**FINAL
ENVIRONMENTAL IMPACT REPORT
YORBA VILLAS RESIDENTIAL PROJECT
SAN BERNARDINO COUNTY,
CALIFORNIA STATE CLEARINGHOUSE NO.
2021060049**

| Section | Page |
|--|------------|
| 2.0 RESPONSE TO COMMENTS..... | 2-1 |
| A1, CITY OF CHINO..... | 2-1 |

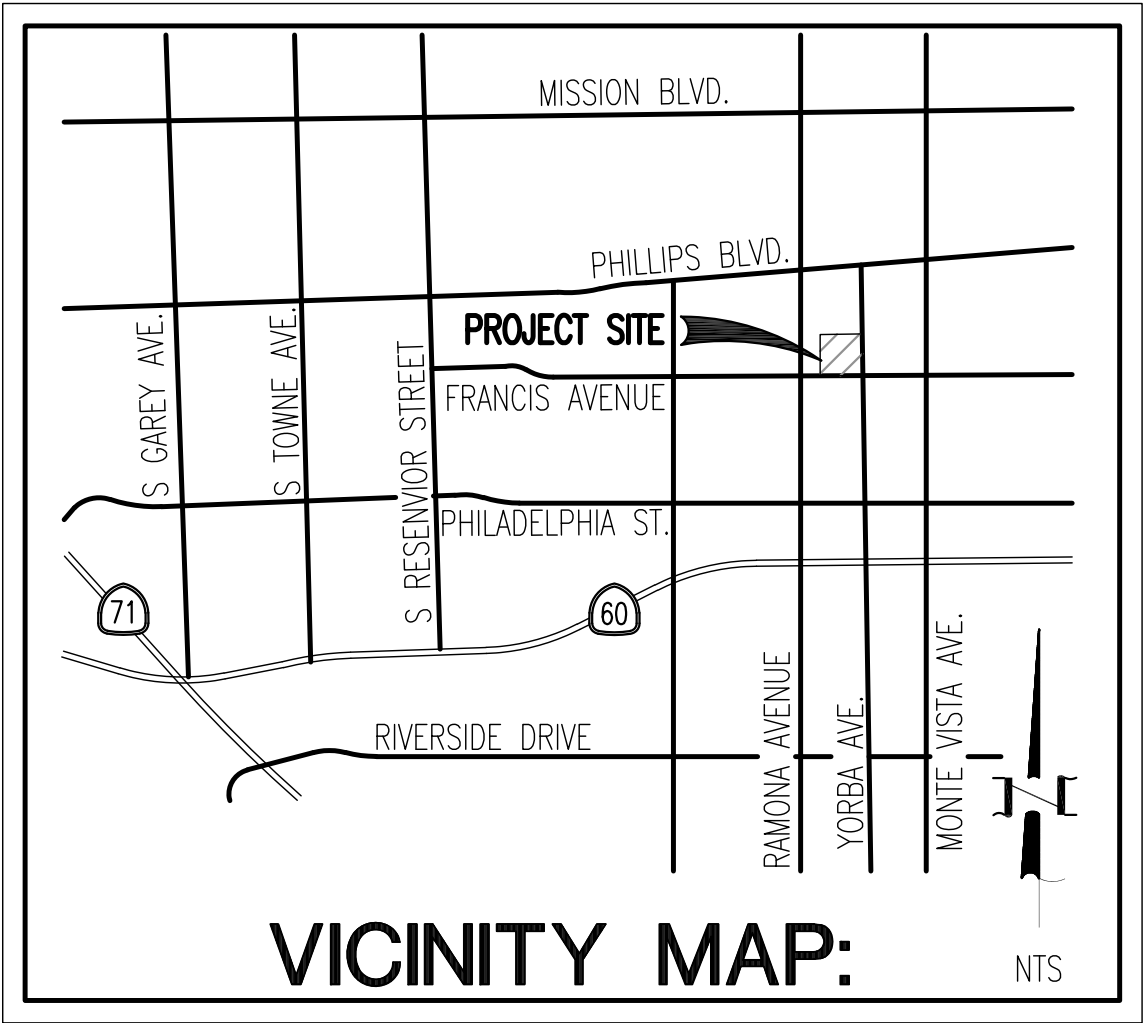
Comment A1.5: This comment states that the Drainage section on page 3-14 indicates that stormwater grate inlets would capture tributary flows that run toward the Project site and convey them around but does not describe or address how these flows will impact the stormwater facilities downstream in the City of Chino. The comment suggests that the EIR should be revised to clearly address downstream stormwater drainage impacts.

Response A1.5: The existing drainage pattern that is tributary to Francis Avenue flows generally from north to south with a slight trend to the west. Approximately one third of the tributary flows drain to Francis Avenue and then easterly to Yorba Avenue. The other two thirds of the tributary flows drain to Francis Avenue and then westerly in Francis Avenue to Ramona Avenue.

The existing drainage pattern that is tributary to the project and to Francis Avenue flows generally from north to south from Phillips Avenue to Francis Avenue, with a slight trend to the west. Approximately one third of the tributary flows drain to Yorba Avenue and Francis Avenue and then south in Yorba Avenue. The other two thirds of the tributary flows drain to Francis Avenue and then westerly in Francis Avenue to Ramona Avenue. The tributary area generally consists of large undeveloped parcels of land, most of which are under cultivation or pasture for large animals.

The westerly two thirds of the project and the westerly tributary area (25.77 acres, Q100=41.8 cfs) currently drain onto Francis Avenue and then westerly to Ramona Avenue and southerly in Ramona Avenue. The easterly one third of the project and the easterly tributary area (14.39 acres including the west half of Yorba Avenue, Q100= 22.8 cfs) drains onto Francis Avenue and then easterly to Yorba Avenue continuing south in Yorba Avenue. As a sidebar, the only existing downstream public storm drain systems are adjacent to the San Bernardino Freeway.

The proposed project intercepts all of the tributary flows along the project's north property line (25.67 acres) in a rectangular concrete channel and conveys all of the tributary storm waters westerly. The tributary flows leave the rectangular channel at the west property line in a concrete pipe which conveys the tributary flows southerly to Francis Avenue where it is outletted onto Francis Avenue and then flows westerly in Francis Avenue to Ramona Avenue. The Q100 storm flow entering Francis Avenue from the westerly and easterly tributary area is 41.20 cfs.
